SUBJECT: MONTICELLO NUCLEAR GENERATING PLANT - ISSUANCE OF  
AMENDMENT RE: REVISION OF REACTOR PRESSURE VESSEL  
PRESSURE-TEMPERATURE LIMIT CURVES AND REMOVAL OF STANDBY  
LIQUID CONTROL RELIEF VALVE SETPOINT (TAC NO. MA4532)

Amendment No.106  
License No. DPR-22

ATTACHMENT TO LICENSE AMENDMENT NO. 106

SAFETY EVALUATION BY THE OFFICE OF NUCLEAR REACTOR REGULATION

Figure 3.6.1 Core Beltline Operating Limits Curve Adjustment vs. Fluence

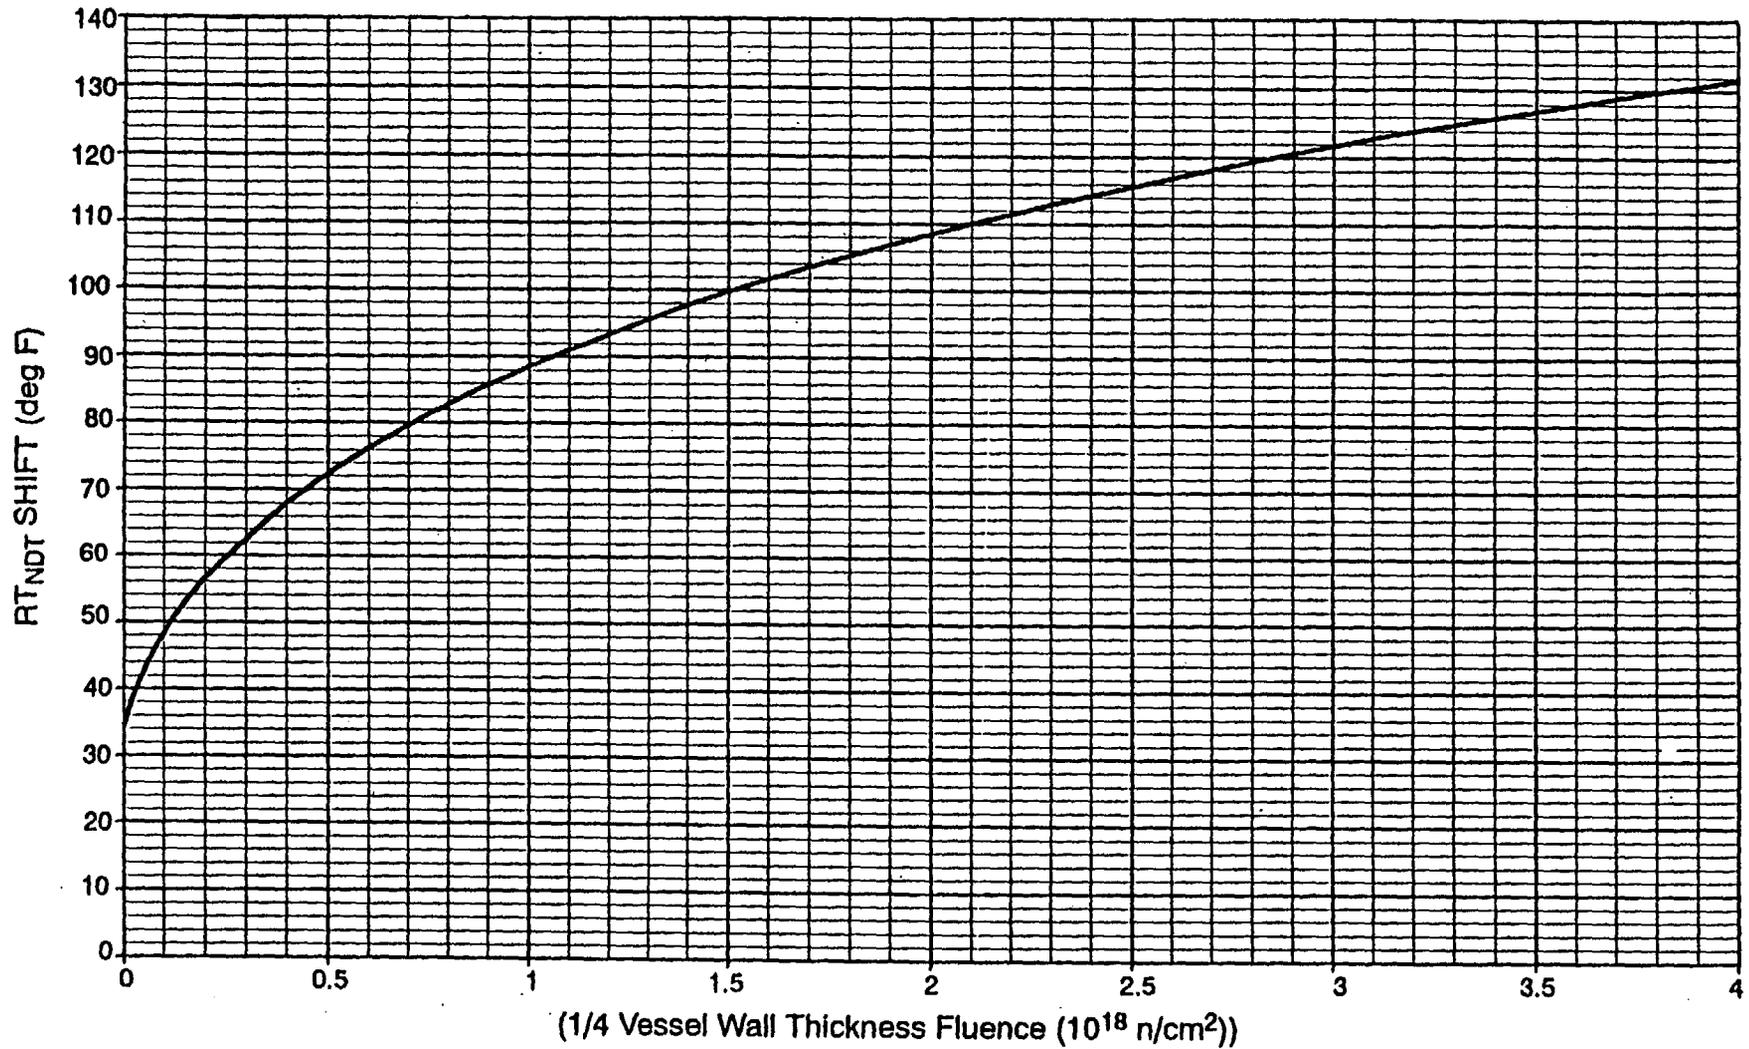
The amendment revises the TS reactor pressure vessel (RPV) pressure-temperature (P-T) limit curves, deletes completed RPV sample surveillance requirements, deletes the requirement to withdraw a specimen at the next refueling outage, removes the standby liquid control system relief valve setpoint, and makes associated administrative changes.

Since these results demonstrated that the previous analysis would be nonconservative at end-of-license (and for any fluence level up to end-of-license), the licensee submitted its December 31, 1998, application to modify the MNGP license by incorporating figures into the P-T limit methodology in the TS that are based on the more conservative material property values above. It should also be noted that since the licensee's evaluation assigned the same initial properties, chemistries, and fluences to the other MNGP lower intermediate shell course plate (I-14, heat C2220-1), that plate was calculated to have the same 1/4T end-of-license ART as plate I-15 and is therefore an equally limiting material.

Note that the results of the staff's analysis show that the CF and end-of-license ART values calculated by the licensee are conservative (higher than the staff's value). Therefore, although the staff does not concur with the basis of the licensee's analysis (i.e., the use of the Prairie Island surveillance data) the staff finds the results of the licensee's analysis to be acceptable. Furthermore, since the results of the licensee's analysis are acceptable, the TS changes proposed by licensee based on their analysis are also acceptable, since they are equivalent or conservative to the analysis results independently calculated by the staff, and their implementation is consistent with the requirement of 10 CFR Part 50, Appendix G.

Figure 3.6.2 Minimum Temperature vs. Pressure for Pressure Tests

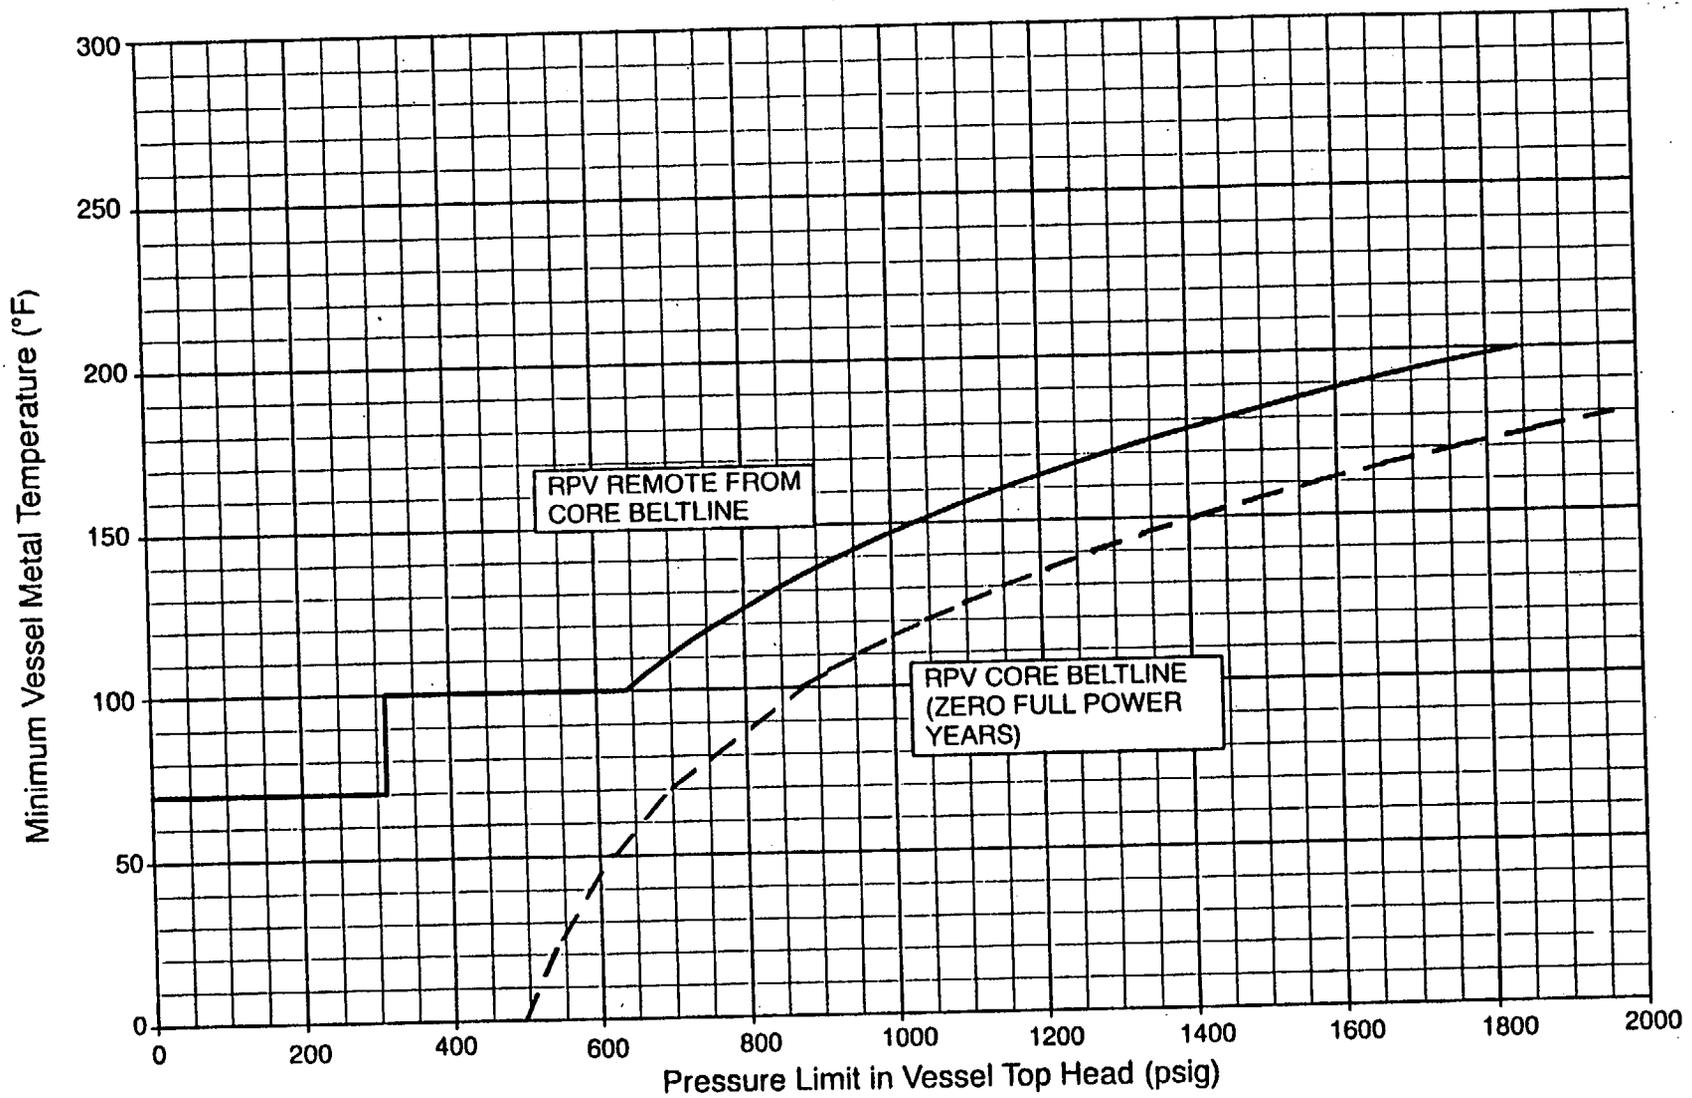
1. During in-service hydrostatic or leak testing, the reactor vessel shell temperatures specified in 4.6.B.1, except for the reactor vessel bottom head, shall be at or above the temperatures shown on the two curves of Figure 3.6.2, where the dashed curve, "RPV Core Beltline," is increased by the core beltline temperature adjustment from Figure 3.6.1. The reactor vessel bottom head temperature shall be at or above the temperatures shown on the solid curve of Figure 3.6.2, "RPV Remote from Core Beltline," with no adjustment from Figure 3.6.1.

Figure 3.6.3 Minimum Temperature vs. Pressure Mechanical Heatup or Cooldown Without the Core Critical

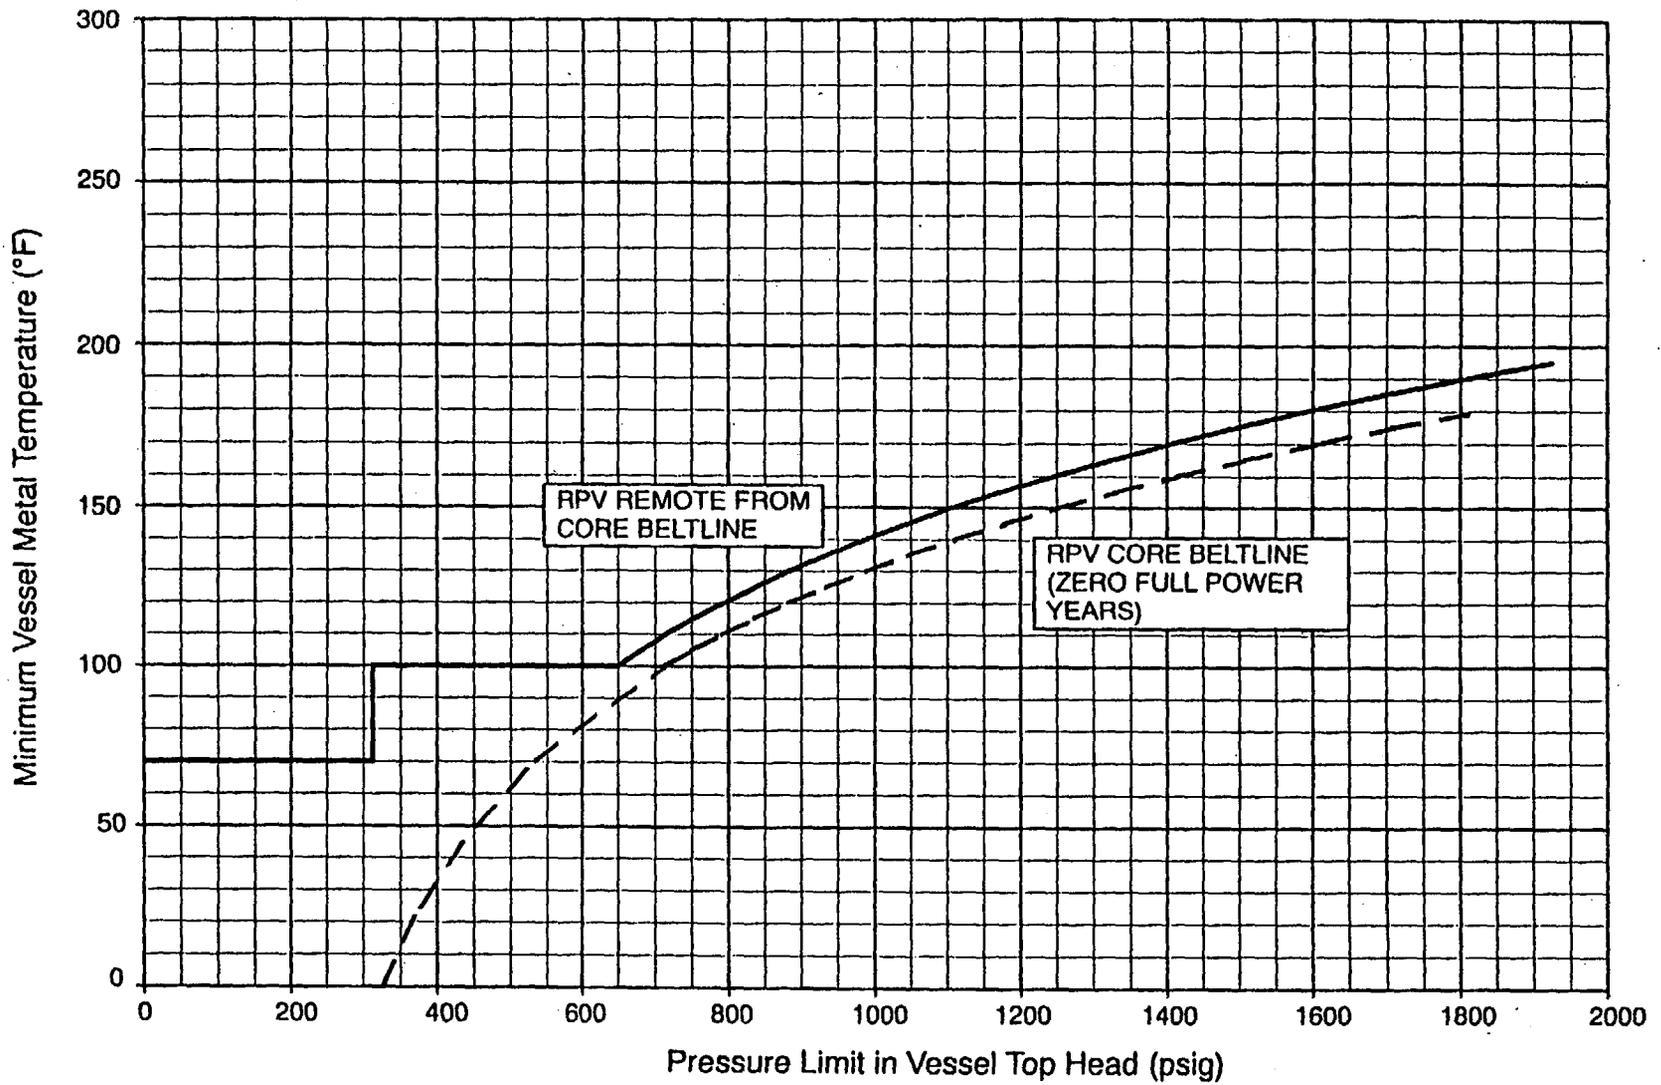
2. During heatup by non-nuclear means (except with the reactor vessel vented), cooldown following nuclear shutdown, or low level physics tests the reactor vessel shell and fluid temperatures specified in 4.6.A shall be at or above the higher of the temperatures of Figure 3.6.3 where the dashed curve, "RPV Core Beltline," is increased by the expected shift in  $RT_{NDT}$  from Figure 3.6.1.

Figure 3.6.4 Minimum Temperature vs. Pressure for Critical Core Operation

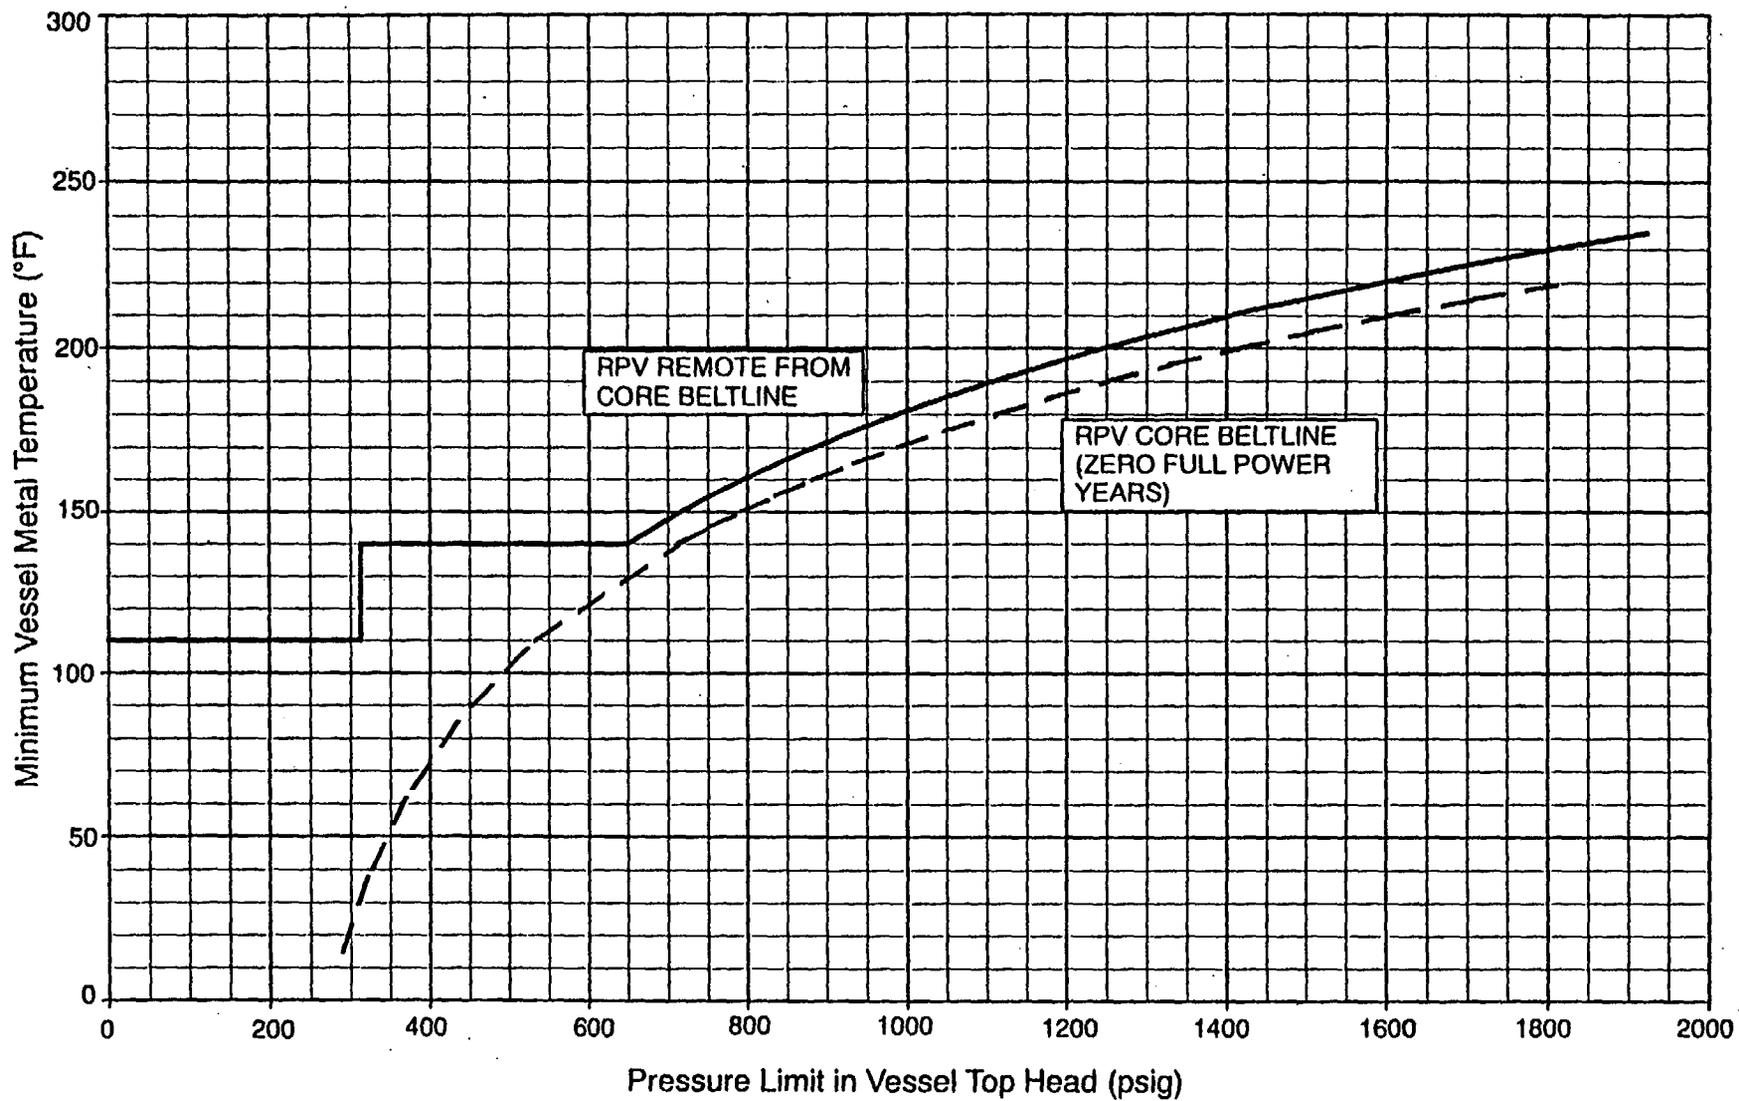
3. During all operation with a critical reactor, other than for low level physics tests or at times when the reactor vessel is vented, the reactor vessel shell and fluid temperatures specified in 4.6.A shall be at or above the higher of the temperatures of Figure 3.6.4 where the dashed curve, "RPV Core Beltline," is increased by the expected shift in  $RT_{NDT}$  from Figure 3.6.1.
